Project: Great Wolf Lodge, Chesterton  
Prepared by: Kathryn Lewis/ David Lewis  
Approved by: Phil Bell  
Date: 04/09/2020

**GREAT WOLF RESORT, BICESTER - STAGE 1 RSA IN RESPECT OF JUNCTION IMPROVEMENT AT MIDDLETON STONEY**

Proposed Junction Improvement at Middleton Stoney

Drawing 1803047-17

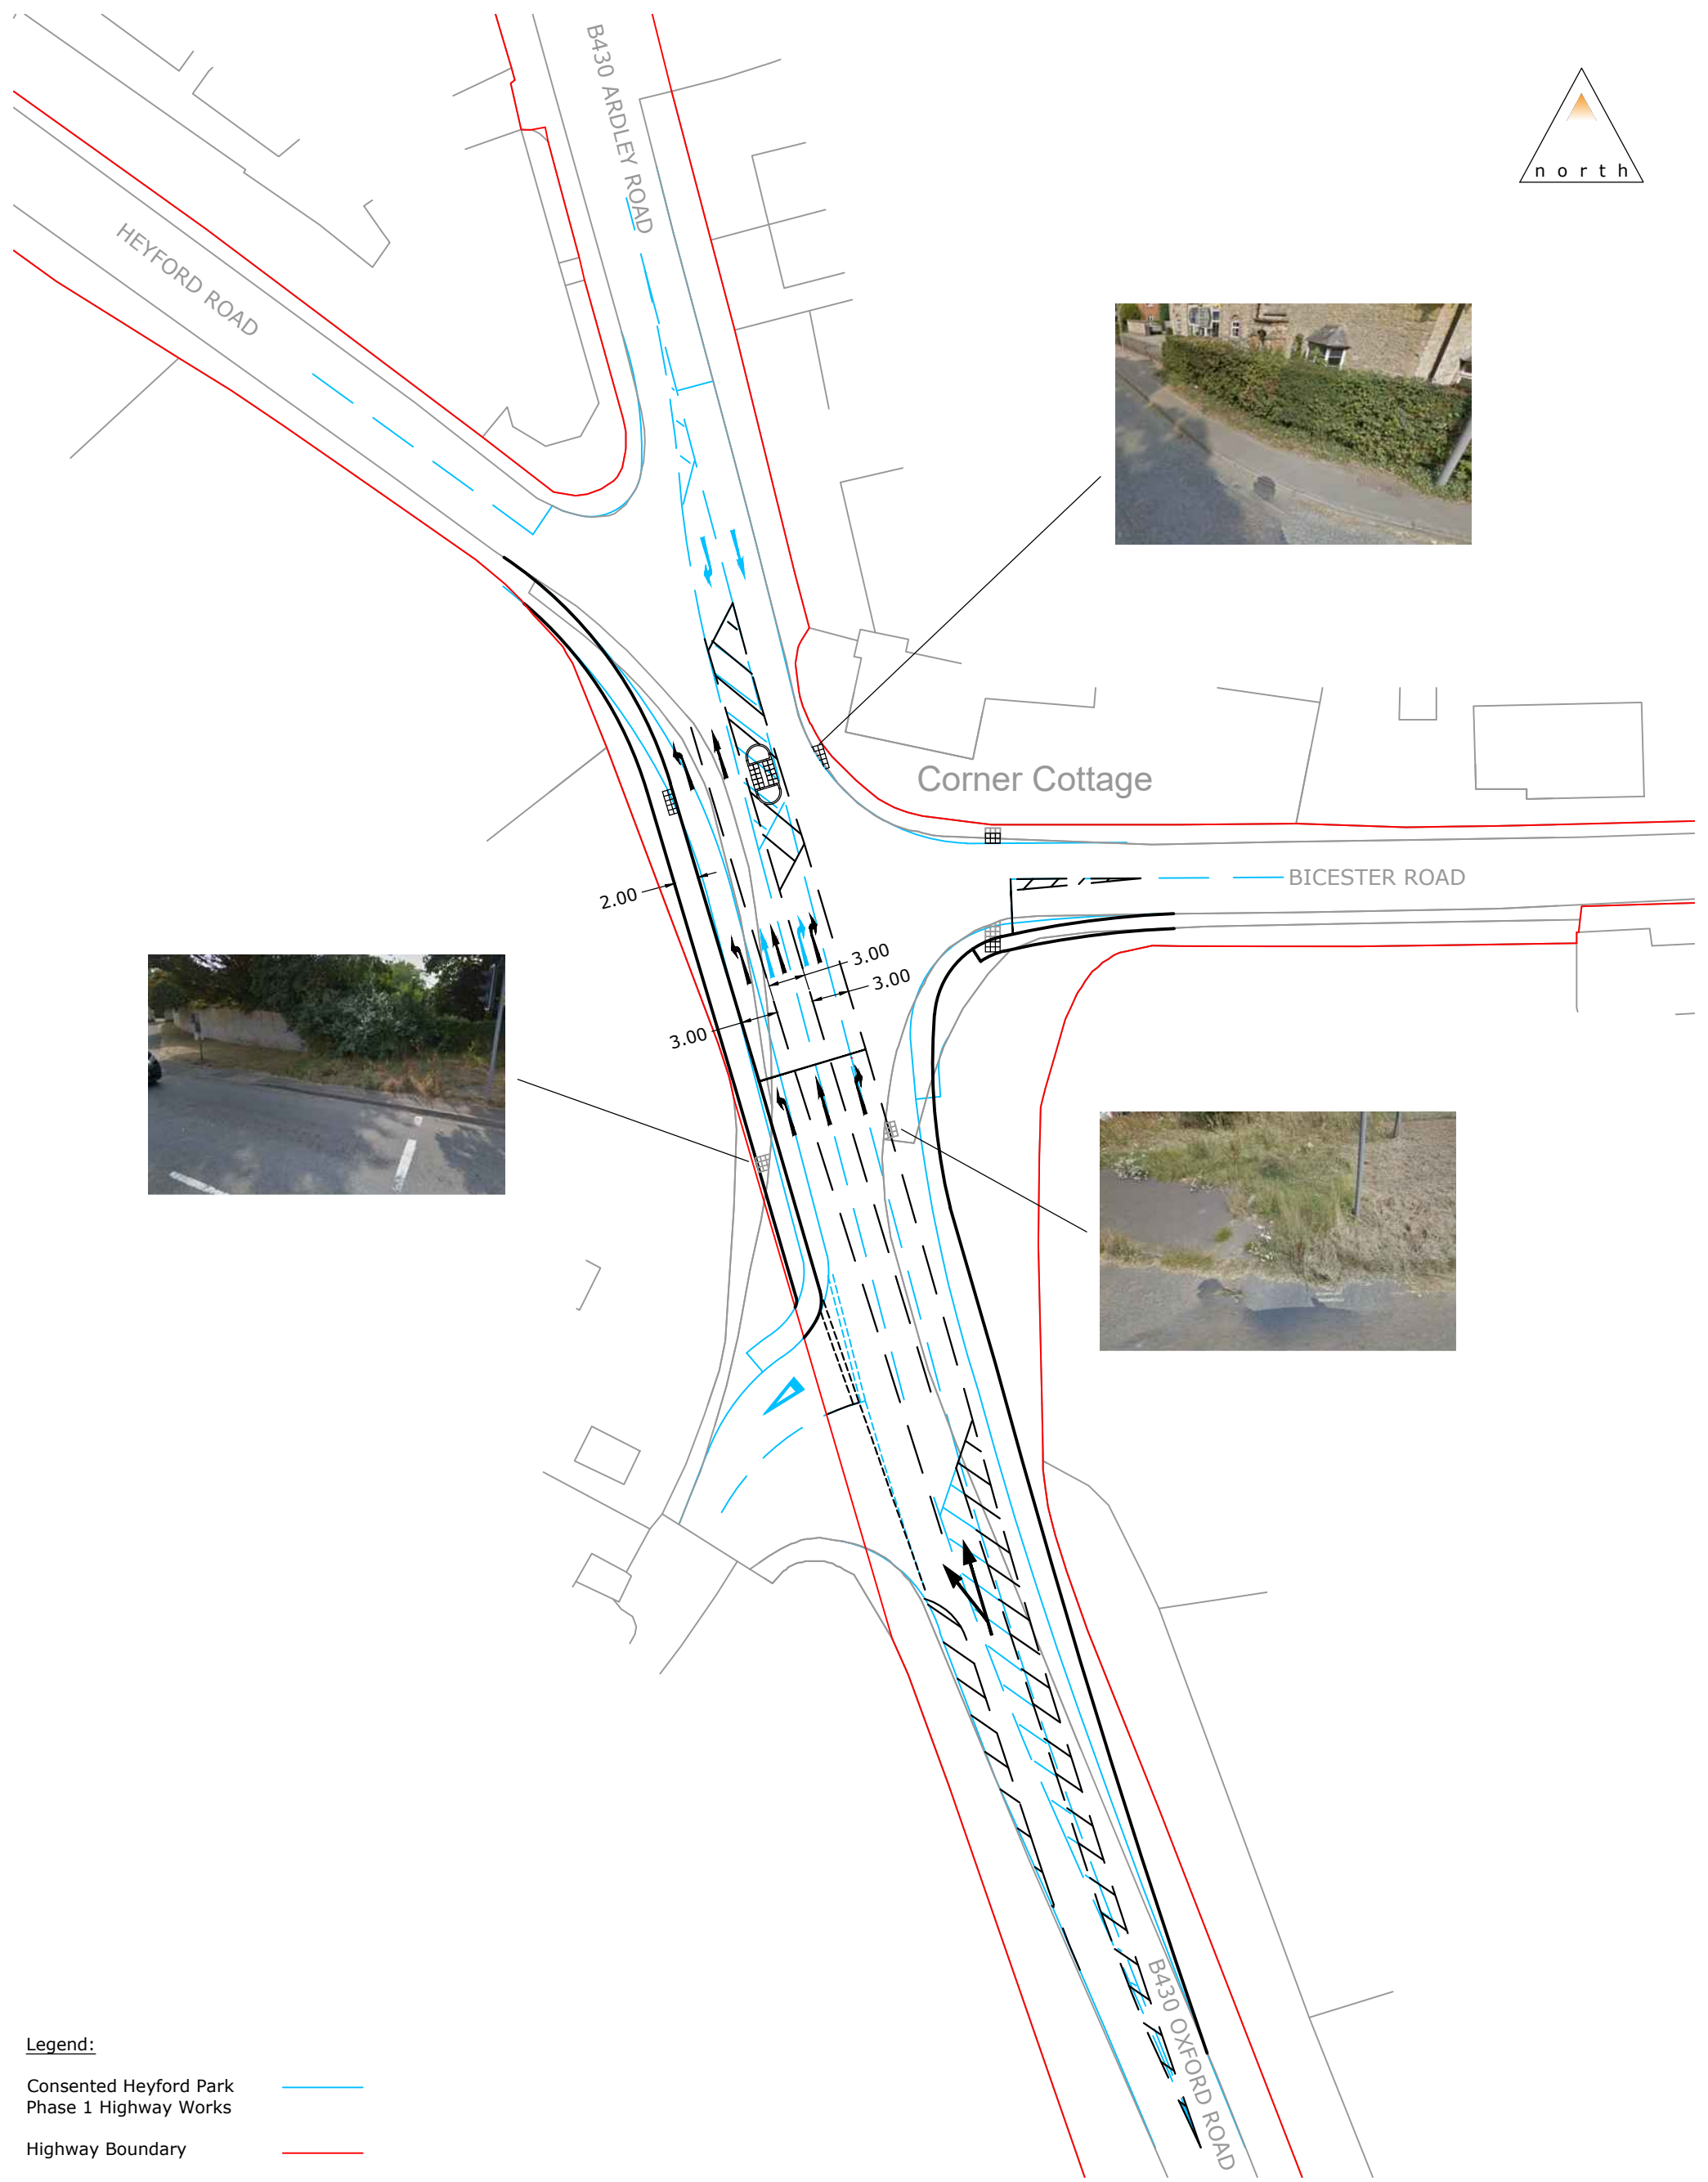
- 3.12 It is noted that OCC provided some commentary on a previous iteration of the proposed highway mitigation works in email correspondence dated 10<sup>th</sup> March 2020. In response to those comments from OCC the proposed highway mitigation scheme has been updated and the following commentary is provided:

- ▶ OCC queried whether it is likely that all vehicles routing north will switch to the central ahead lane in advance of the stopline and some northbound traffic may remain in the nearside left turn lane and this could result in vehicles merging after the stopline. The mitigation works include changes to the road markings in advance of the northbound stopline. The amended road markings mean that the straight-ahead northbound lane is a continuous lane with the new turning lane towards the B4030 west filtering to the left. Vehicles continuing northbound on the B430 will not be required to change lanes and only the turning traffic (left and right) will be required to switch into the respective turning lanes. On that basis it is considered that the majority of vehicles will be utilising the correct lane at the stopline and it is unlikely that vehicles will be required to merge or change lanes after the stopline. Furthermore, it is considered that signage in the form of dedicated lane advance direction signs (as set out at Section 6 of Traffic Signs Manual Chapter 7) can be installed in advance of the junction to advise drivers the appropriate lane at the stopline and detail of signage will be provided at the detailed design stage;

- ▶ OCC noted that queuing vehicles in the northbound straight-ahead lane could block vehicles entering the proposed new left turn lane. In response, it is highlighted that the junction capacity modelling has been undertaken using LinSig and this assesses the utilisation of the proposed flared left turn lane based on the proposed dimensions and adjusts the utilisation of that lane based on expected queuing in the central lane and the potential for queuing to block access to the left turn filter lane. On that basis, the junction modelling presented in this Note reflects the proposed layout and the likely utilisation of both ahead and the new left turning lane;

- ▶ Given the distance from the application site, the Great Wolf development proposals will not result in a change in the number of pedestrian movements at the junction. The proposed new pedestrian crossing point and pedestrian refuge showing on Drawing 1803047-17 are a significant betterment over current pedestrian facilities at the junction. The existing pedestrian crossing is located to the south of the junction, which is not on the desire line for pedestrians crossing between the majority of local dwellings and local services, such as the local pub. At present, and under the consented Heyford Park Phase 1 mitigation scheme, pedestrians are required to cross the width of the B430 in a one movement with no refuge in the centre of the carriageway. Furthermore, the existing pedestrian crossing facility is positioned in advance of the northbound stopline such that pedestrians are currently required to walk in between queueing vehicles. The proposed pedestrian crossing arrangements, detailed at Drawing 1803047-17, provides a new pedestrian refuge allowing pedestrian to cross the B430 in two movements and wait safely in the centre of the carriageway. The arrangement also moves the pedestrian crossing point from a location in advance of the northbound stopline, to within the junction and this means that pedestrian are no longer required to cross in between queueing traffic and this is considered a safer arrangement. Furthermore, the proposed pedestrian crossing point and refuge provide the opportunity for pedestrians to cross the northbound and southbound carriageway of the B430 during traffic-free phases within the junction signal plan. For example, a pedestrian can cross the southbound carriageway of the B430 during the green phase for the B4030 Bicester Road and there will be no conflict between pedestrians and vehicle movements. Similarly, a pedestrian can cross the northbound carriageway during the green phase for the B4030 Heyford Road and there will be no conflict between pedestrians and vehicles. In comparison, under the current pedestrian crossing arrangements pedestrians crossing the B430 will always be in conflict traffic movements either on the B430 or turning from the B4030. In addition, the new pedestrian crossing point and refuge is located within the junction and this is on the desire line for pedestrians routeing between local dwellings and services and is therefore considered more convenient for pedestrians.

- 3.11 The proposed scheme of works has been prepared and is presented at Drawing 1803047-17, attached at [Appendix A](#). The proposed works will be in addition to those consented as part of the Heyford Park Phase 1 and can be accommodated within the existing adopted highway at the junction. The works comprise the provision of an additional northbound dedicated left turn lane at the junction along with minor changes to the south-eastern kerblines and road markings and adjustments to the signal timings at the junction.

<small>At: High Street 10, High Street Bicester OX26 4AJ T: 01295 263 262 F: 01295 255 522</small>	Project: <b>Great Wolf Resort, Bicester</b>
	Title: <b>Indicative Mitigation Works</b>
<small>Scale: 1:500 (E: A3)</small>	Drawing: <b>1803047-17</b>
<small>Notes:</small>	Revision: <b>B</b>

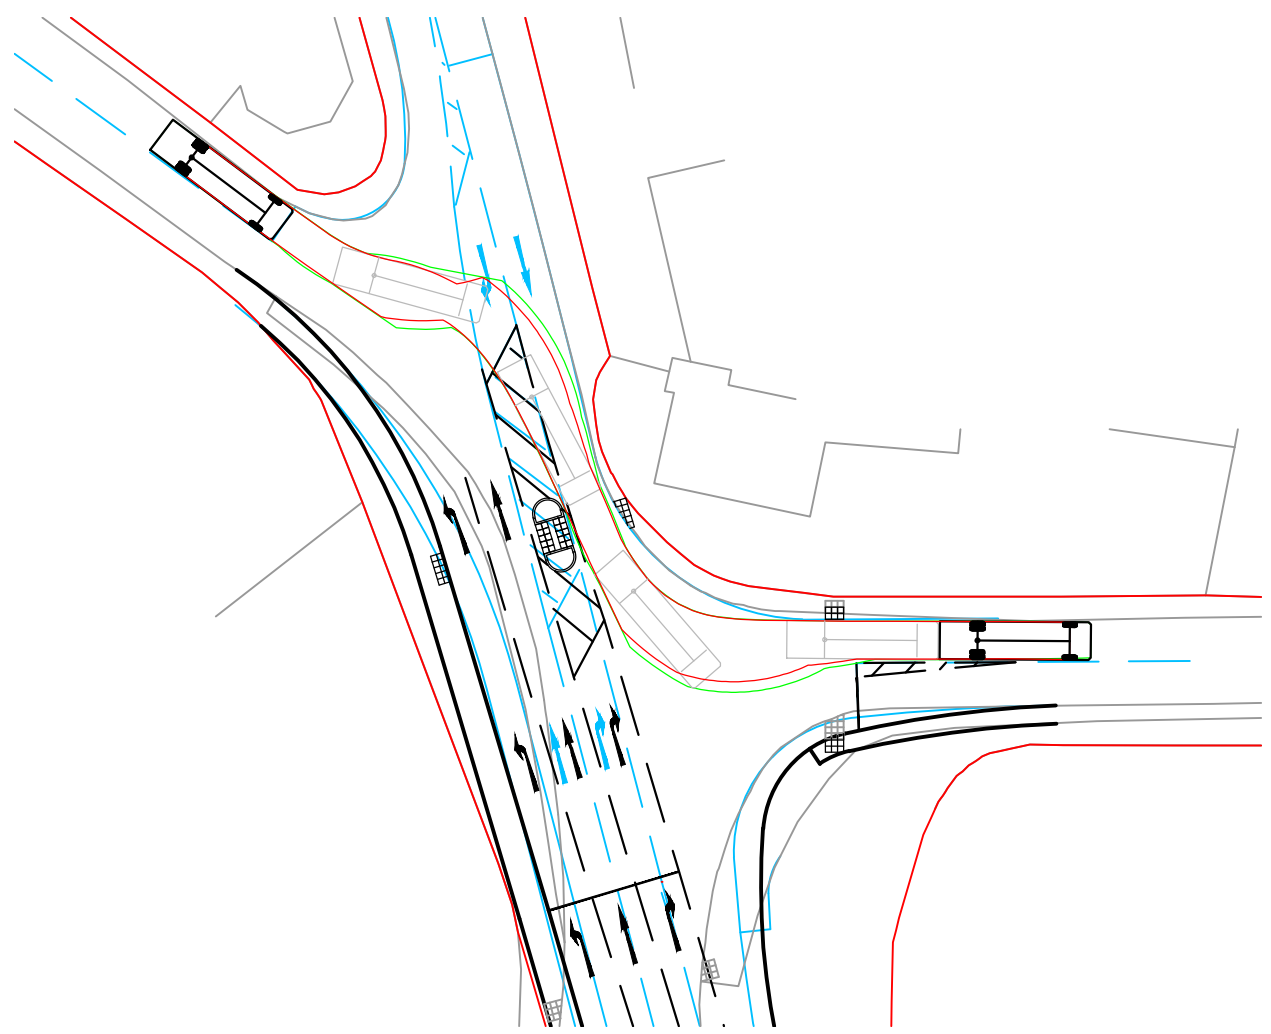
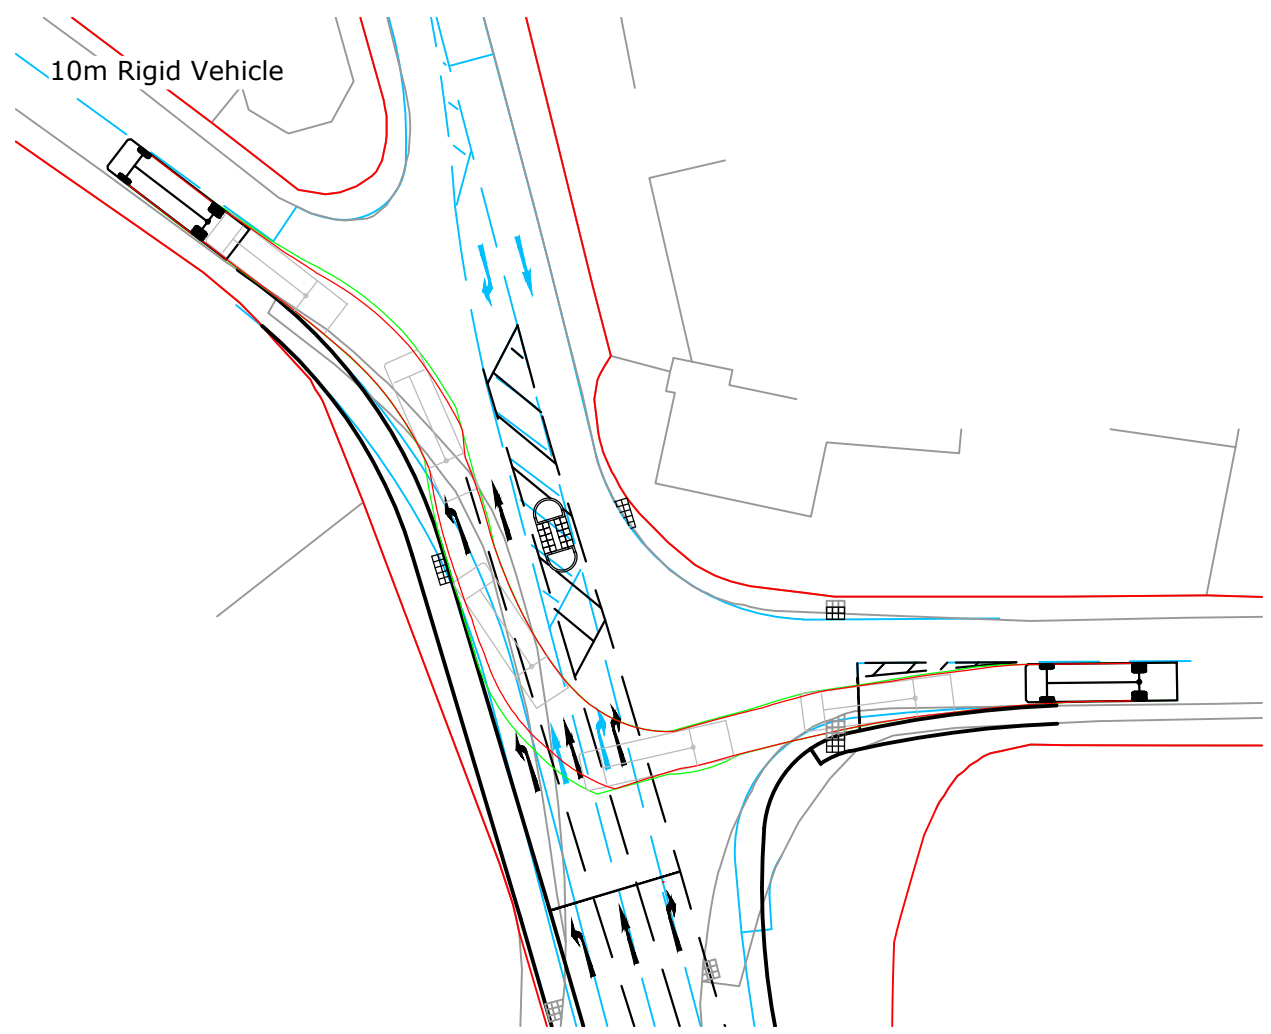
Footway width could lead to pedestrians being struck by vehicles

The footway width at this location is presently reduced by verge overgrowth and, to a lesser extent, the boundary hedge. Pedestrians waiting to cross would therefore necessarily stand close to the kerb, potentially leaving them vulnerable to a collision with a passing vehicle.

Northbound drivers approaching the junction may not be aware of the lane assignment and could make late lane changes, leading to side impact collisions.

Risk of head-on collisions between right turning vehicles

Drivers turning right into Middleton Park may inadvertently stray into the right turn lane for Bicester Road, leading to heads-on collisions.

Risk of collisions involving vehicles emerging from an uncontrolled access into the controlled area

Drivers emerging from the private access may not know which traffic stream has priority (a green signal) and could collide with a vehicle passing through the junction.

Risk of vehicles, cyclists and pedestrians colliding with street furniture

Street furniture and lighting details are not available to the Audit Team and it is acknowledged this will be a detailed design matter, for consideration at Stage 2 RSA. However, if street furniture is not mounted appropriately it could be struck by pedestrians, cyclists or vehicles.

5.4

5.6

5.3

5.5

Problem 5.7 throughout scheme

Cut back the verge overgrowth at the back of footway on the east side of Ardley Road, particularly at the proposed uncontrolled crossing. Also trim back the boundary hedge within the highway as far as possible.

Provide a lane designation/destination sign on the northbound approach to the junction.

On Oxford Road, provide additional road markings (e.g. arrows) and/or road studs between the southbound lane and the right turn lane to enhance legibility of road layout.

Provide a traffic signal head on the proposed pedestrian refuge, facing Ardley Road (southbound) but also visible to the drivers emerging from the private access.

At the detailed design stage, ensure that street furniture will be carefully located/mounted to minimise the risk of vehicle strikes and obstruction of pedestrians/cyclists.

5.1	n/a			
5.2	n/a			
5.3	Cut back the verge overgrowth at the back of footway on the east side of Ardley Road, particularly at the proposed uncontrolled crossing. Also trim back the boundary hedge within the highway.	The footway width is unchanged as part of the proposed highway works, but opportunity to cut back overgrowth and boundary hedges to improve clear footway width can be reviewed at the detailed design stage.

5.4	Provide a lane designation/destination sign on the northbound approach to the junction.	Lane designation signage can be provided on approach to the junction and this can be included at the detailed design stage.

5.5	On Oxford Road, provide additional road markings (e.g. arrows) and/or road studs between the southbound lane and	Additional road markings and/ or road studs can be provided and this can be included at the detailed design stage.

the right turn lane to enhance legibility of road layout			
5.6	Provide a traffic signal head on the proposed pedestrian refuge, facing Ardley Road (southbound) but also visible to the drivers emerging from the private access	The positioning of signal heads will be designed at the detailed design stage but it is considered that one can be provided on the refuge island. Position of signal heads on traffic islands is commonplace and is shown, for example, at Figures 7.2.9N and 7.16Na of DMRB CD123.		
5.7	At the detailed design stage, ensure that street furniture will be carefully located/mounted to minimise the risk of vehicle strikes and obstruction of pedestrians/cyclists.	Noted. At the detailed design stage, the positioning of street furniture will consider this.
